LOWER MINNESOTA RIVER WATERSHED DISTRICT

Lower Minnesota River Watershed District Board of Managers Meeting
Wednesday, May 19, 2021

Re: Area 3 Minnesota Riverbank Stabilization Project Update

Re: East Chaska Creek Restoration—Construction Update

Photo Location #6: View downstream from Crosstown Boulevard bridge and approximate locations of the gas and fiber-optic utilities.

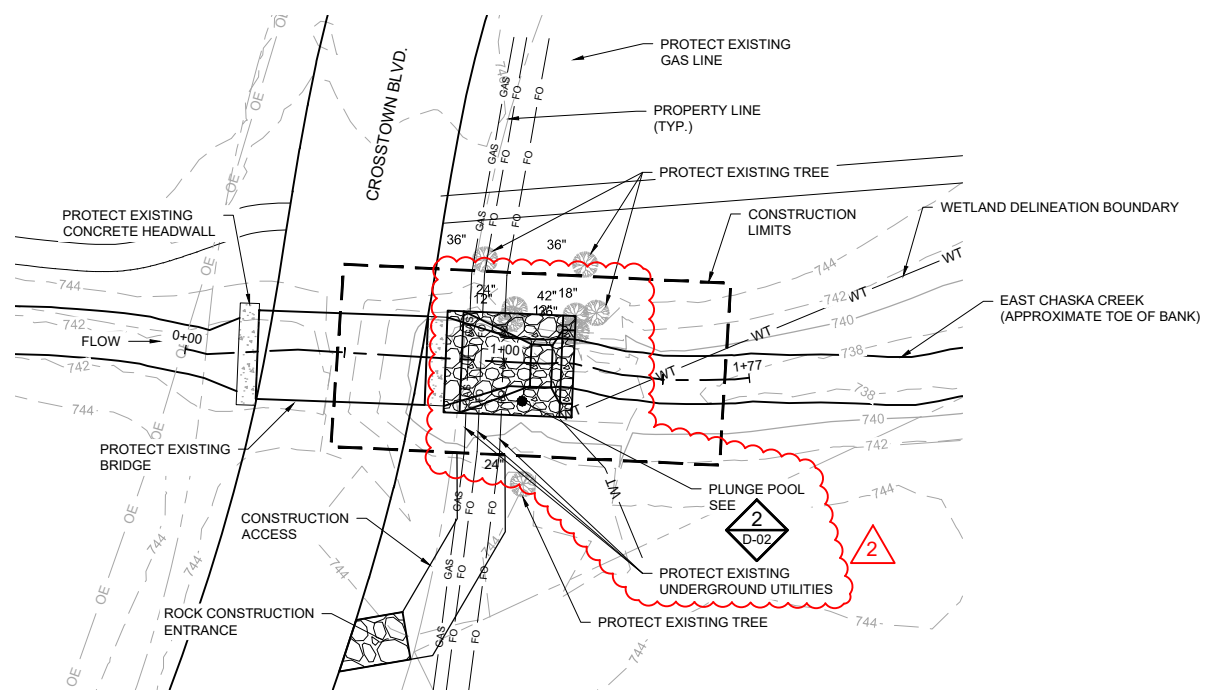
At Crosstown Boulevard, the previous utility locate flag showing the location of the high-pressure gas main downstream from the bridge was still present (Attachment 1, Photo 6). Given the location of the main directly underneath the proposed plunge pool, it was agreed that the plunge pool would be shifted downstream, past the gas main, so that no excavation would occur immediately on top of the main. Sand, filter fabric, and salvaged riprap would be placed on top of the gas main location to extend the bridge apron elevation beyond the gas main, at which point the plunge pool and final boulder weir could be constructed.

Following the site walk, Blackstone called in a new utility location survey and returned to the site on Friday May 7, 2021, to complete the majority of the finish grading, confirmed by the City of Chaska. The utility locate showed the presence of a fiber-optic line approximately five to ten feet downstream from the gas main. The City discussed adjusting the design further by shifting the plunge pool another ten feet, beyond the fiber-optic line. This alternative would increase the amount of riprap needed, but the additional amount needed will have to be determined based on the proposed solution.

Young Environmental met with Barr on May 12, 2021 to discuss the proposed field fit and whether altering the design would present any issues with the permits. Barr has developed a solution that continues to meet the permit obligations while also protecting the existing utilities (Attachment 2). Further coordination is expected to continue this week, and staff will be prepared to provide an update to the managers as needed.
